**Correspondence Between
Staff and Applicant
Approval Letter**

RE 26-ZN-2016
The Reserve at Black Mountain

Thank you for your review of The Reserve at Black Mountain Rezoning applications referenced above. All first review comments have been responded to and incorporated into the revised submittal.

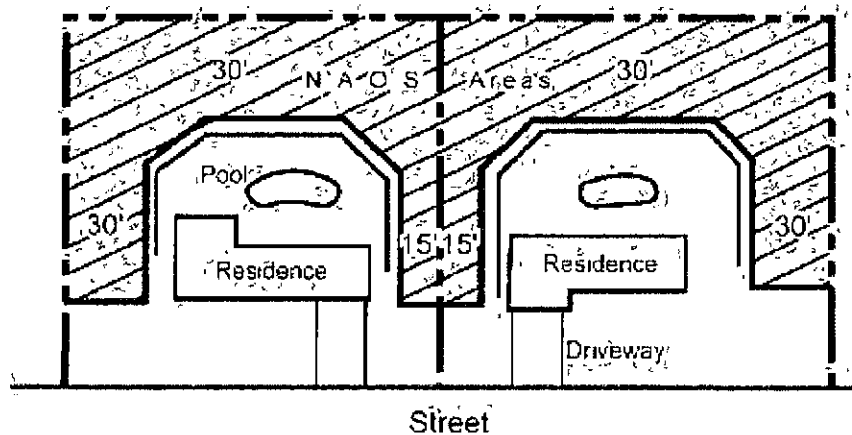
- ✓ 9 Natural Area Open Space (NAOS) is calculated from the subject site’s gross acreage, not the net acreage (Zoning Ordinance Section 6 1060) The allowable disturbed NAOS square footage and percentage is calculated from the required NAOS amount (14 89 acres), not the provided amount (16 38 acres) Please revise NAOS data table accordingly

Response – The applicant has updated the Slope Analysis exhibit and NAOS exhibit to reflect open space calculations being derived from the gross acreage

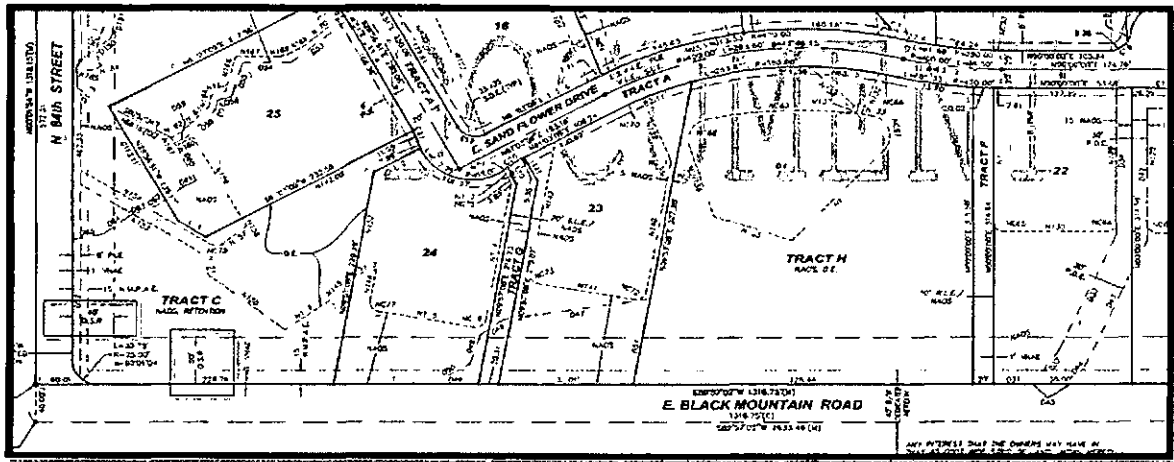
- ✓ 20 Consider Community Mobility Goal 5, Approach 1 and Goal 7, Approach 2 regarding the proposal to maintain access to 84th Street and Black Mountain Road for the two existing homes The curb cut for the existing home on Lot 7 is very close to the entry for Vista Viento located to the north and could be eliminated with access provided via the private street in the development Similarly, the curb cut for Lot 27 could be eliminated and access provided through the private street in the development

Response – The existing homes have indicated their preference to retain access independence from the proposed community Due to the local collector classification of both Black Mountain Road and 84th Street, the applicant believes that retaining access is both safe and acceptable Discussions with Transportation staff support

maintaining existing driveway locations if these two affected lots are provided access to internal private streets. The applicant has modified the site plan to show connectivity to internal streets via tracts or envelope extensions that will allow for future connectivity if the property owners of Lots 7 and 27 when and if they should want this

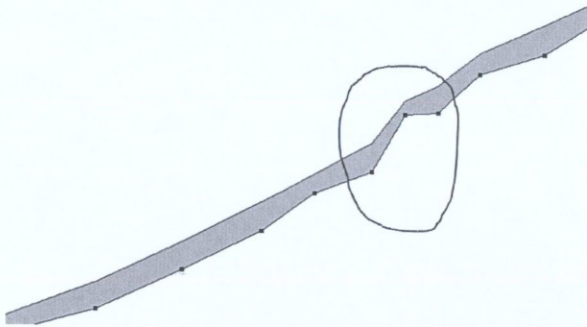
- ✓ 41 Please update case drainage reports to identify and callout all retaining walls, if any (DSPM Section 4-1 901)

Response - Retaining walls are shown on the grading plan, which is provided within the drainage report (There are not more than a handful of retaining wall locations)
